**CONTRACT NO. DE-AC27-01RV14136 – TRANSMITTAL FOR INFORMATION -
AUTHORIZATION BASIS CHANGE NOTICES**

Bechtel National, Inc. (BNI) is submitting fifteen Authorization Basis Change Notices (ABCN) in accordance with BNI-approved procedure 24590-WTP-GPP-SREG-002, Revision 5, *Authorization Basis Maintenance*, to the U.S. Department of Energy, Office of River Protection, and the Safety Regulation Division (OSR) for information (attached). The contractor-approved ABCNs listed in Attachment 1 are a result of the Hanford Tank Waste Treatment and Immobilization Plant's design evolution changes.

JOB NO.	DRAWING NUMBER	REV NO	TITLE OF DRAWING
24590	24590-PTF-M6-PWD-00002	0	P&ID - PTF PLANT WASH & DISPOSAL SYSTEM EFFLUENT COLLECTION PWD-VSL-00033/00043/00044 (Q)

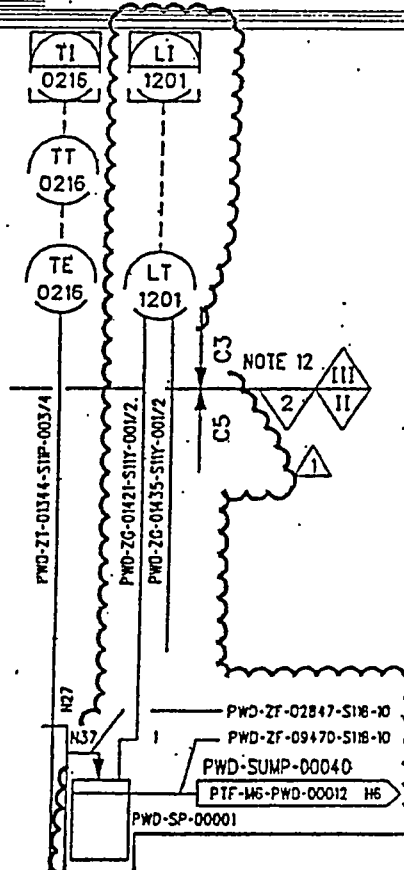
DESCRIPTION OF CHANGE
